Crystal River Nuclear Plant  
Docket No. 50-302  
Operating License No. DPR-72

July 20, 2011  
3F0711-04

Subject: Crystal River Unit 3 – License Amendment Request #310, Revision 1, Departure from a Method of Evaluation for the Auxiliary Building Overhead Crane, Revisions to Associated Commitments, and Response to Request for Additional Information (TAC No. ME5208)

**Figure 1: OBE Envelope Response Spectra for Aux. Bldg. Steel Structure**

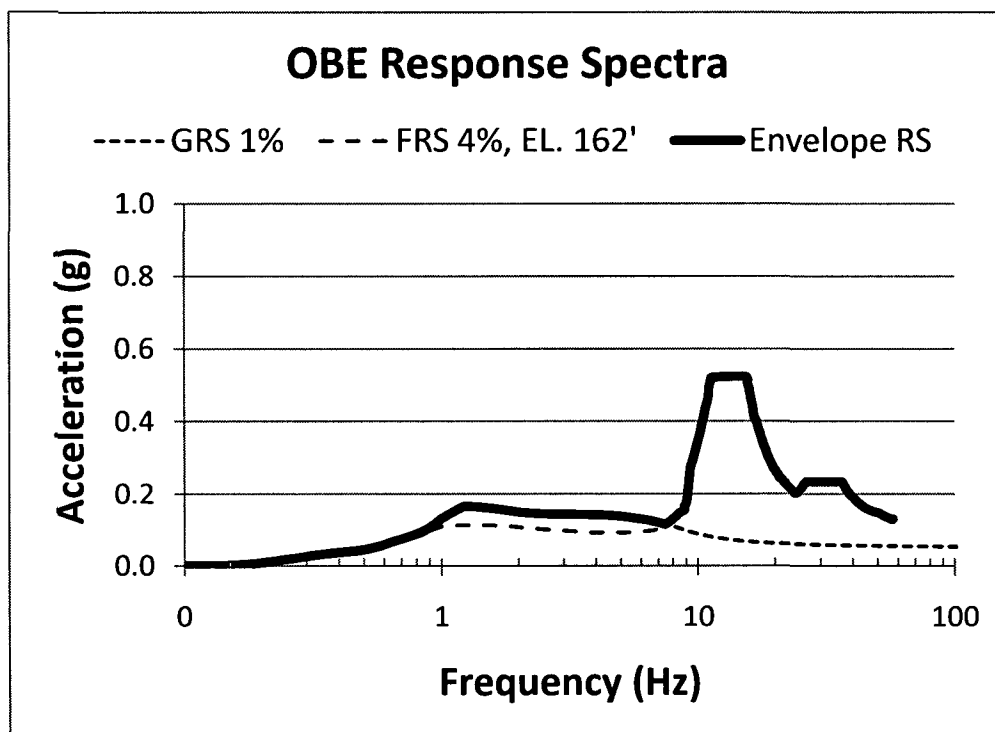
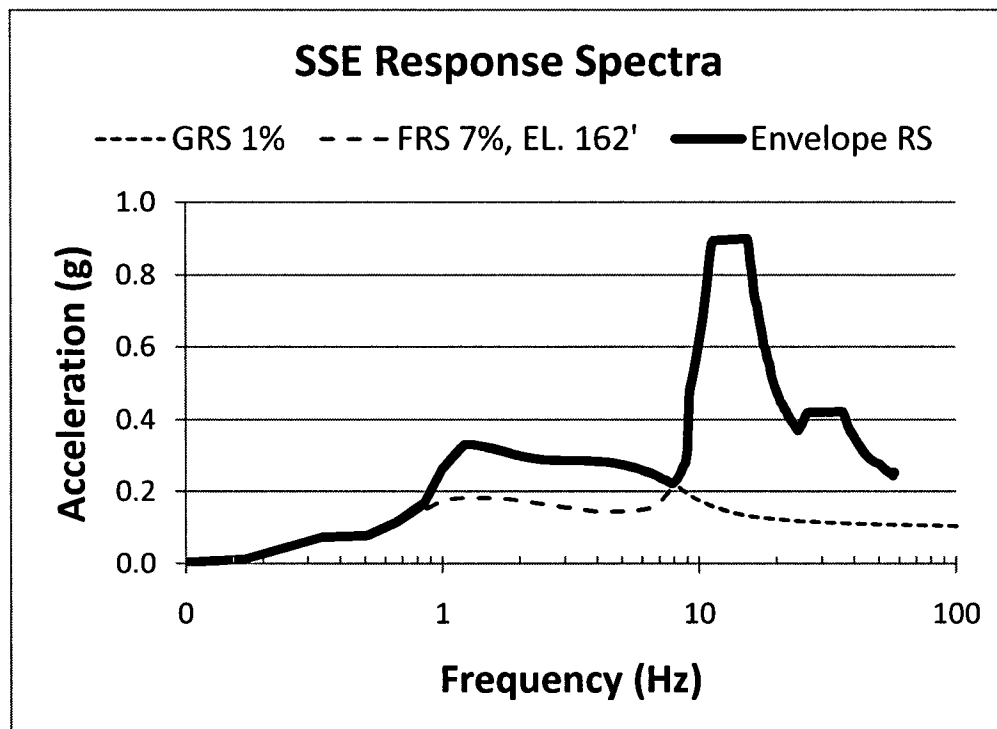
*Provide technical justification for application of the ASME NOG-1-2004, crane structural damping values to the crane support structure rather than using reconciled values (i.e., values applicable to the crane and crane support coupled structure that consider those damping values applied in the licensing analyses for other Class 1 steel structures at CR3). This technical justification should address the rigidity of the connection between the reinforced concrete auxiliary building structure and the steel crane support structure.*

The ground response spectra (GRS) at 1% damping was used as seismic input specific for building response. This was consistent with the original design of the steel building, which conservatively used the damping value specified in the FSAR for welded steel structures (1%) despite being a primarily bolted steel structure (2.5%). While the design calculations for the steel building evaluate seismic input using the OBE design spectra, the new analysis evaluates both OBE and SSE GRS inputs, each considering 1% damping. Accepted structural damping values in the more recent NRC RG 1.61 (2007) are 3% (OBE) and 4% (SSE) for welded steel or bolted steel with friction connections, and 5% (OBE) and 7% (SSE) for bolted steel with bearing connections. The 1% damping value used with GRS seismic input specific to the building analysis is thus conservative with respect to recommended values in RG 1.61 (2007) and therefore in compliance.

The floor response spectra (FRS) at elevation 162' of the underlying concrete building at 4% and 7% damping (OBE and SSE, respectively) were used as input specific for crane response. In an uncoupled model, the crane would be treated as equipment and analyzed using a floor response spectra at the level of the crane runway girder (top of rail elevation 193'-7"); however, in a coupled model, input specific to the crane response must be incorporated into the overall seismic input being applied to the base of the steel building structure, thus creating the need for the envelope spectra. The selection of 4% and 7% damping values used with FRS seismic input specific to the crane response were chosen to be consistent with crane damping requirements in ASME NOG-1-2004.

As noted in Appendix 2 of FPC118-PR-001, the envelope spectra is governed by GRS contributions at relatively low frequencies, and by FRS contributions at relatively high frequencies. The crossing frequency was noted as 7.47 Hz for OBE, and 7.85 Hz for SSE (see Figure 1 and Figure 2). A crossing frequency of 7.64 Hz represents an approximate average crossing frequency over various damping values of FRS and GRS constituents.

Response of the steel crane support structure should be governed by the portion of the envelope spectra below the crossing point (GRS portion) due to its inherent flexibility relative to the stiffness of the underlying concrete structure (further justification provided in ‘Structural Dynamics Explanation’ section). The FRS contribution was included primarily to support the independent seismic analysis by the crane vendor, in case the crane has high-frequency sensitive components. Using a single envelope spectrum incorporating GRS and FRS constituents is therefore a conservative approach for seismic input to the coupled model.
